THOMAS PARK POOL AUDIT

CITY OF COLLEGE STATION
Home of Texas A&M University®

March 2018

Introduction

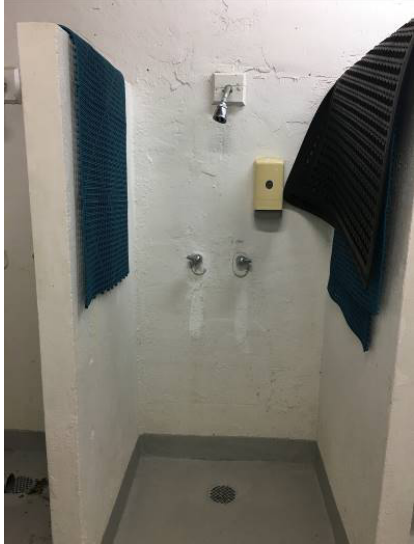
Plumbing fixtures appear to be original to the building. City staff noted that there are ongoing issues with clogged drains, leaks, and faucet handle failure. Trench drains in the restrooms are present, but the grates are non-removable thus making it quite difficult to clean out the trench or unclog the drain. Most notably it was observed that the number of plumbing fixtures is small. Based on the occupancy and current code requirements, there should be 3 water closets provided for the

women's room (per Texas Administrative Code, based on 250 pool occupants); however, there are only 2. Current code requires 2 fixtures for the men's room, and there are 2 fixtures. Concerning lavatories, per Texas Administrative Code for pools, there should be 2 sinks per gender. However, there is only 1 in each restroom area.

Code requires a janitor's sink; none is present.

A water heater was observed; it was not seen if this water heater has an anti-scald mechanism required by Section 265.201 of the Texas Administrative Code.

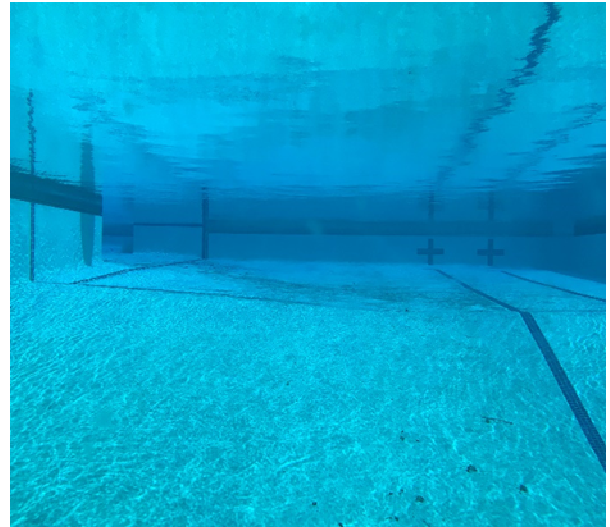
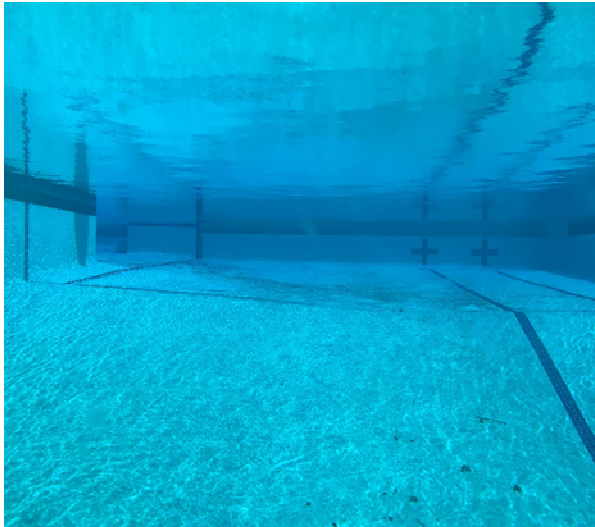
The Lap/Recreation Pool perimeter overflow system is a fully recessed stainless-steel gutter system with an integral pressure tube for return water. The stainless-steel gutter was retrofitted into this pool in 2002 along with updates to the pool concrete, main drains, filter room piping and pool finishes.

Due to the excessive daily water loss and consistent wet spots on the pool deck, its logical to assume that a portion of the water loss is due to leaks in the pool gutter. The likely location is the pressure tube providing filtered and chemically treated water back to the pool. Typically, leaks in stainless steel gutters can be found at weld joints, change of direction locations and flange locations.

At the time of my review, water level in the pool was approximately 1 ½" to 2" below rim overflow condition.

The gutter pressure tube and all connecting piping (suction and pressure) should be pressure tested to confirm all leak locations. Deck removal will likely need to occur to repair leak points. Any welding repair to the stainless-steel gutter should be performed by a qualified welder experienced with stainless steel pool gutters

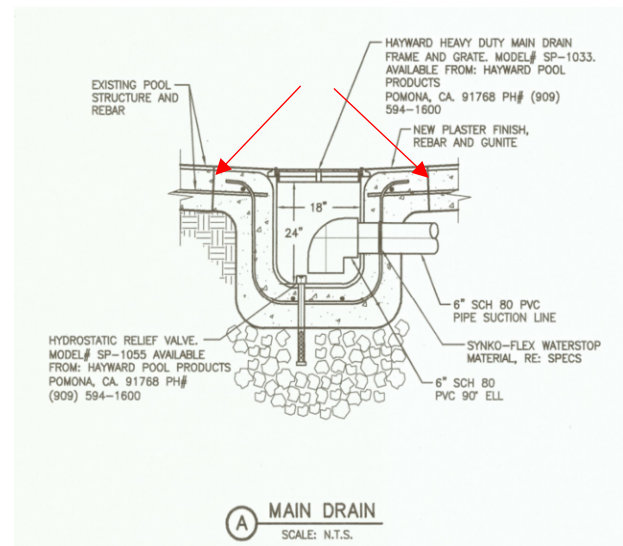
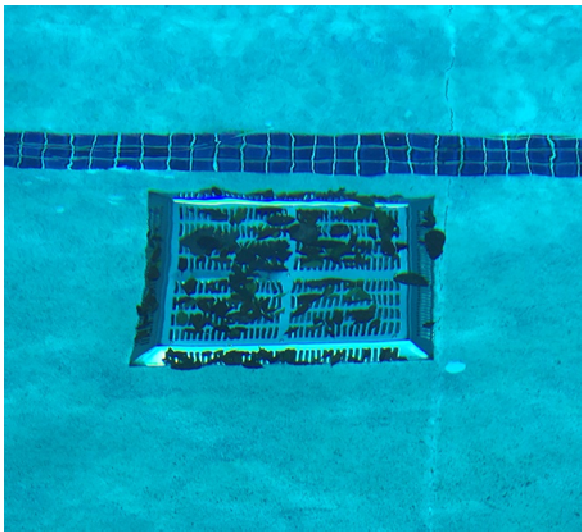
The original pool shell was constructed in 1979 and renovated in in 1993 & 2002. It should be noted that the current life expectancy of a concrete pool shell is approximately 30 to 40 years. The pool was full of untreated water at the time of my visit. Therefore, my inspection of the pool shell and finish was minimal. Pool staff reported that the pool loses an estimated 200,000 to 225,000 gallons of water a month. This calculates to 6,700 to 7,500 gallons a day or 5+ gallons a minute.

Pool drawings provided by city staff indicate that the pool experienced extensive concrete crack and joint repair in 1993. Additionally, the pool was originally designed with floor inlets. All floor inlets were “capped and abandoned” in 2002.

Pool staff also relayed that the pool expansion joints have been a concern for pool leakage.

The pool finish could not be observed since the pool was full of water. Staff relayed that the plaster finish is questionable and needs to be replaced. Typically, plaster finishes for outdoor pools last 8 to 10 years based upon water quality and proper chemical balance.

Due to the age and current condition of the existing pool structure, Counsilman-Hunsaker recommends draining the pool, remove the plaster finish to the bare concrete pool structure (methods may include sandblasting, hydro-blasting, or other mechanical abrasive means) and consult a structural engineer to inspect the structural integrity of the pool. Hammer testing or borings may be required to determine potential voids under the pool shell.

Due to the age and current condition of the existing pool structure and the lengthy list of issues, it is recommended to provide a new reinforced concrete pool structure if not initially required by the structural engineering assessment.

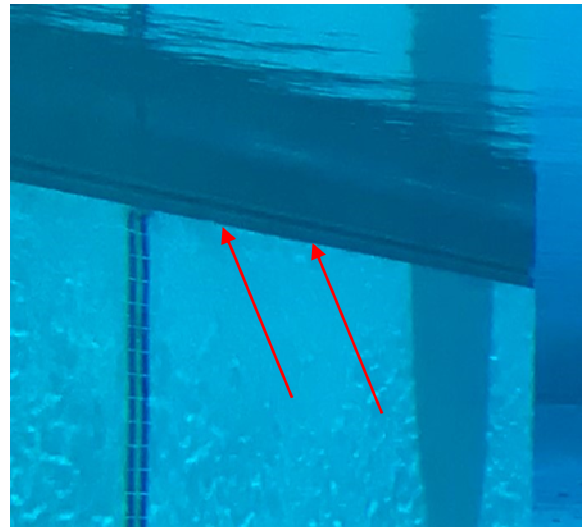
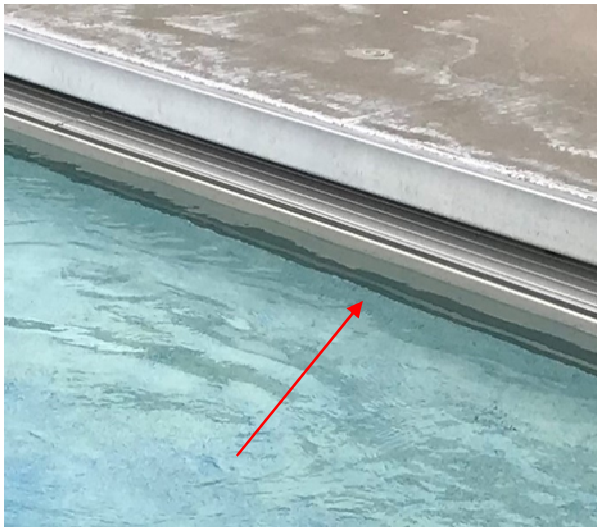
The main drains in the Lap/Recreation Pool could not be inspected due to the pool being full of untreated water. The drain covers appear to be the Hayward SP-1033 installed as part of the 2002 renovation. Please note, these main drain covers are not VGB (Virginia Graeme Baker) compliant. All pool main drains in public pools are to be compliant per the Virginia Graeme Baker Pool and Spa Safety Act (VGB) ASME/ANSI A112.19.81 signed into Law on December 19, 2007.

The main drain replacement detail shown below taken from the 2002 renovation drawings does not show water stop at the concrete cold joint. Unless this was addressed during construction, this could be contributing to the loss of water the pool is experiencing.

After plaster coating is removed, use a high-pressure epoxy injection system to seal the concrete cold joints.

Install VGB compliant main drain covers.

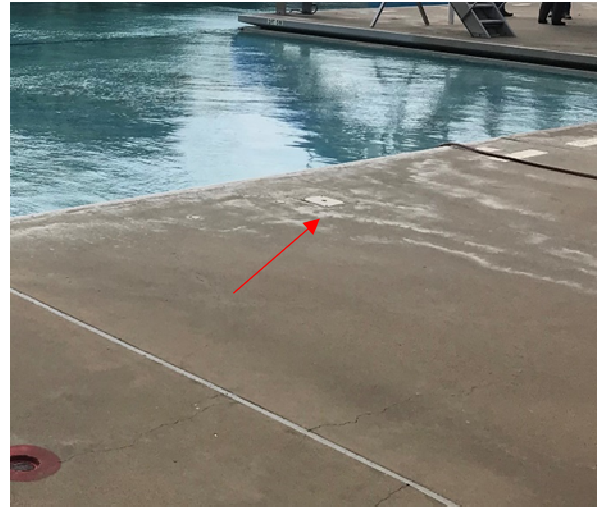
Horizontal depth markers are 6" x 6" tiles with 4" lettering located on the pool deck behind the recesses gutter. No diving markers are located on the pool deck at depths of 5'-0" and less. Vertical depth markers are located on the face of the stainless-steel gutter.

No action needed. Current depth markers meet all code and safety requirement.

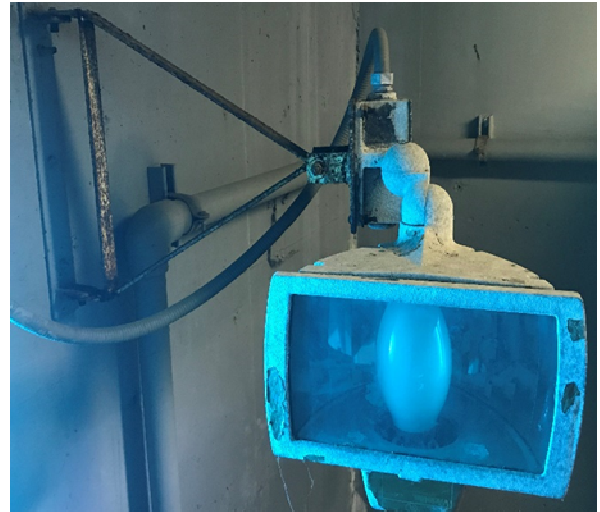
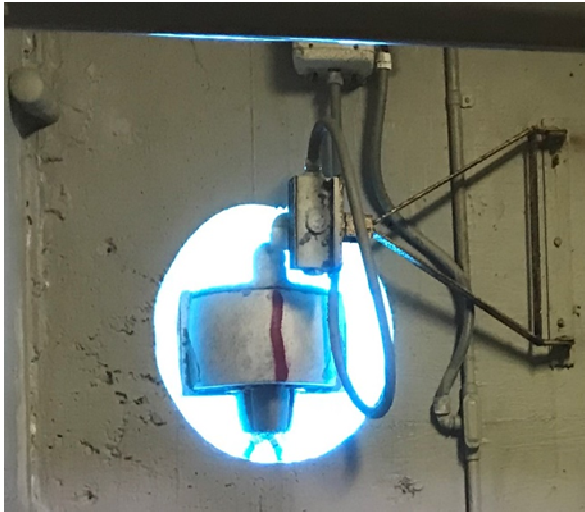
The Lap/Recreation Pool is equipped with one underwater light located at the deep end of the pool. The light is a dry-niche style light located within the filter room pump and piping pit. The view port for the light is watertight with no visible leaks. The light swing arm is operational and functions as designed. Pool staff relayed that the light is operational and is used occasionally.

Rule 265.192 (o) of the Texas Administrative Code Notes the following:

Electrical safety of underwater lights in post-10/01/99 and pre-10/01/99 pools and spas. Underwater lights are not required in post-10/01/99 and pre-10/01/99 pools and spas. If the lights have no epoxy insulation, have cracked insulation, have spliced connection cords, or have been modified in violation of an applicable electrical code, they shall be replaced with lights complying with this section.

Confirm underwater light are properly bonded as per NEC 680.

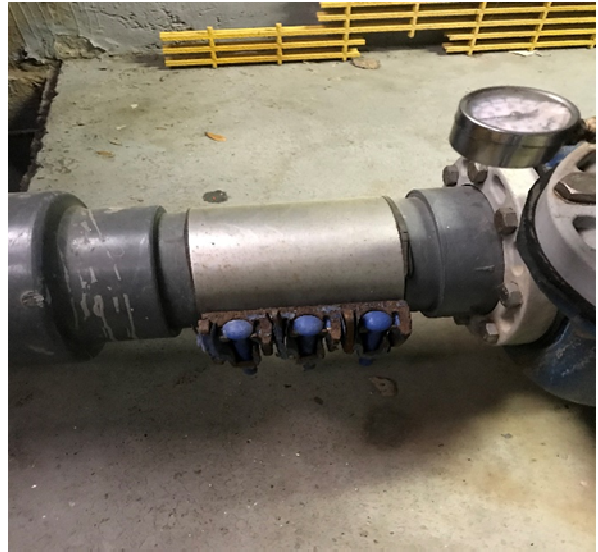
The aquatic safety protocol was not discussed at the time of the site visit. It is recommended to take inventory of the present equipment to ensure compliance with all local and state codes. The following safety equipment items should be found throughout the facility and its support spaces.

According to the Texas Administrative Code, *If the pool has between 2,000 and 4,000 square feet of water surface area, an additional reaching pole and throwing rope with*

ring buoy, as described in subparagraphs (A) and (B) of this paragraph shall be provided. If the pool has over 4,000 square feet of water surface area, an additional reaching pole and throwing rope with ring buoy as described in subparagraphs (A) and (B) of this paragraph shall be provided for each 6,000 square feet of water surface area or portion thereof over 4,000 square feet. All such lifesaving equipment shall be mounted in conspicuous places around the pool deck within 20 feet of the pool. All lifesaving equipment shall be kept in good repair and ready condition.

(2) Backboards at post-10/01/99 and pre-10/01/99 pools. Post-10/01/99 and pre-10/01/99 Class A and B pools and Class C pools that have a diving board, slide, or lifeguard shall have one or more backboards with a minimum of 3 tie down straps and head immobilizer for back and neck injuries. (3) First aid kits at post-10/01/99 and pre-10/01/99 pools. Post-10/01/99 and pre-10/01/99 Class A and B pools and other pools with lifeguards shall be equipped with a first aid kit meeting OSHA requirements. First aid kits shall be a standard 24-unit kit and housed in a durable weather resistant container and kept filled and ready for use (including disease transmission barriers and cleansing kits that meet OSHA standards).
